L-2010-169
10 CFR 50.90
August 5, 2010

Re: Turkey Point Units 3 and 4
Docket Nos. 50-250 and 50-251
License Amendment Request No. 207
Fuel Storage Criticality Analysis

Enclosure
Turkey Point Units 3 and 4
License Amendment Request No. 207
Fuel Storage Criticality Analysis

Attachment 1
Turkey Point Units 3 and 4
License Amendment Request No. 207
Fuel Storage Criticality Analysis

FIGURE 5.5-4

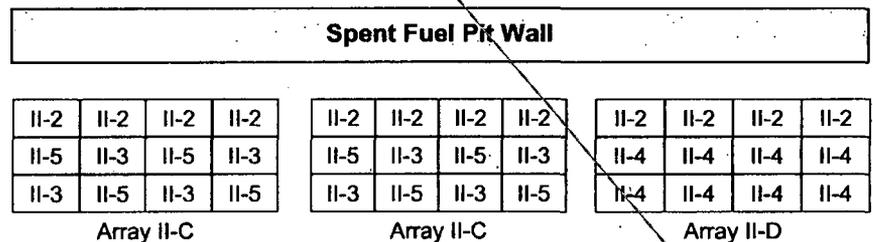
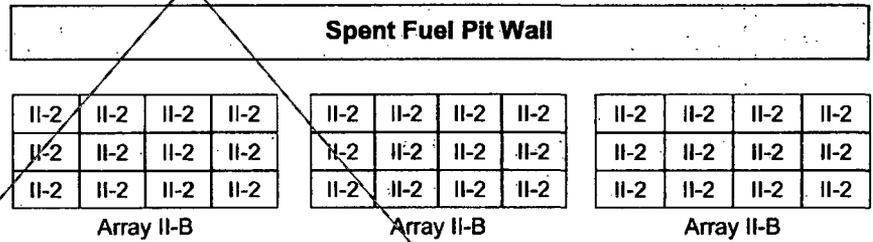
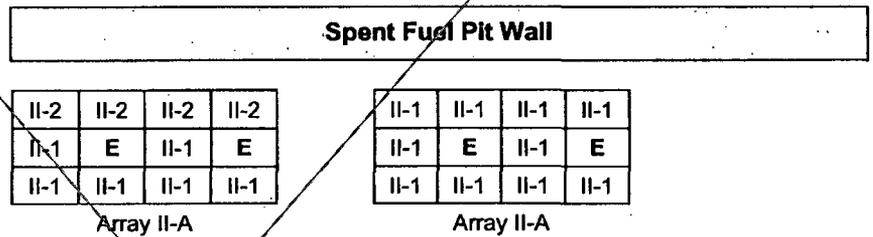
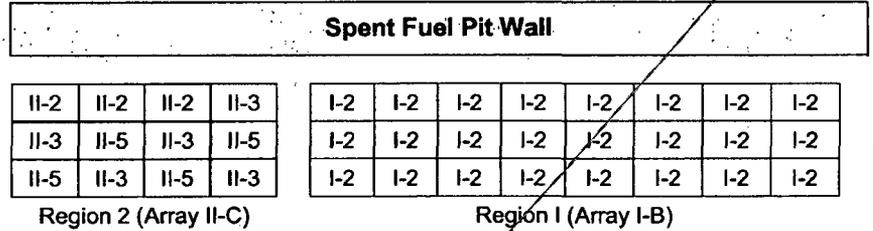
Figure 5.5-4 Figure completely revised.

Figure 5.5-4 Figure completely revised.

An assembly of rank II-2 placed in the peripheral row of a Region II storage rack shall not be adjacent to a Region I storage rack.

For Array II-A, the empty cell in the 2x2 II-A array shall be adjacent to the peripheral row that contains the category II-2 assembly(s). For Array II-A only, the peripheral row may contain category II-1 assemblies as the outer two rows will comply with Array II-A requirements.

FIGURE 5.5-4

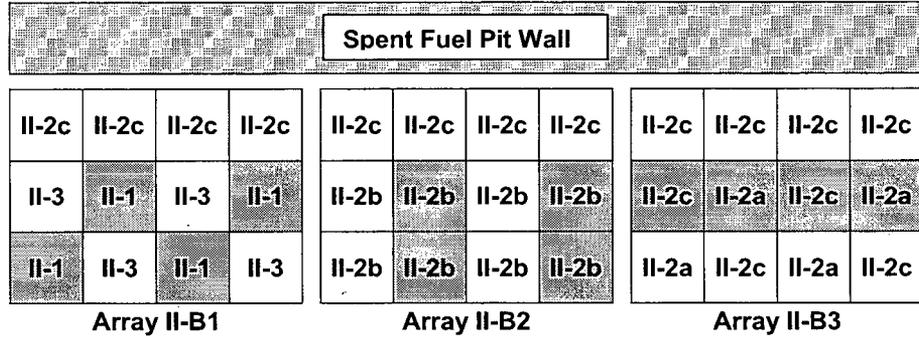
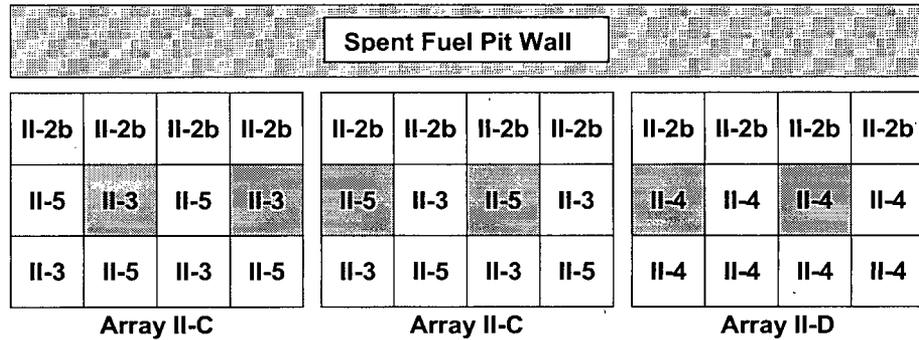
ALLOWABLE EXCEPTIONS TO REGION II STORAGE ARRAYS WHEN ADJACENT TO SPENT FUEL PIT WALLS

For Arrays requiring two inserts, there shall be an insert in at least every other cell adjacent to the peripheral row containing the II-2c assemblies.

For Arrays requiring one insert, the insert shall be adjacent to the peripheral row containing the II-2b assemblies.

- d. Any 2x2 array of Region II storage cells may adjoin a row of assemblies with a reactivity category of II-2b (or lower reactivity) that is located in the outer row adjacent to the spent fuel pit wall. The outer row of reactivity category II-2b (or lower reactivity) fuel assemblies need not contain any Metamic inserts or full length RCCAs, as long as the fuel is loaded to comply with the allowable storage patterns defined in Figure 5.5-4.

Basis for the Change: Technical Specification 5.5.1.3.d is updated to reflect analysis results that revise the reactivity categorization of new and spent fuel assemblies, where former category II-2 is further divided into categories II-2a, II-

2b, and II-2c. In addition, where Region II storage arrays are permitted to contain higher reactivity fuel assemblies adjacent to the spent fuel pit wall (taking advantage of neutron leakage at the wall boundary), additional requirements have been imposed via Figure 5.5-4 that consider the effect of adjacent interior arrays that further limit the reactivity category of the storage cells adjacent to the wall.
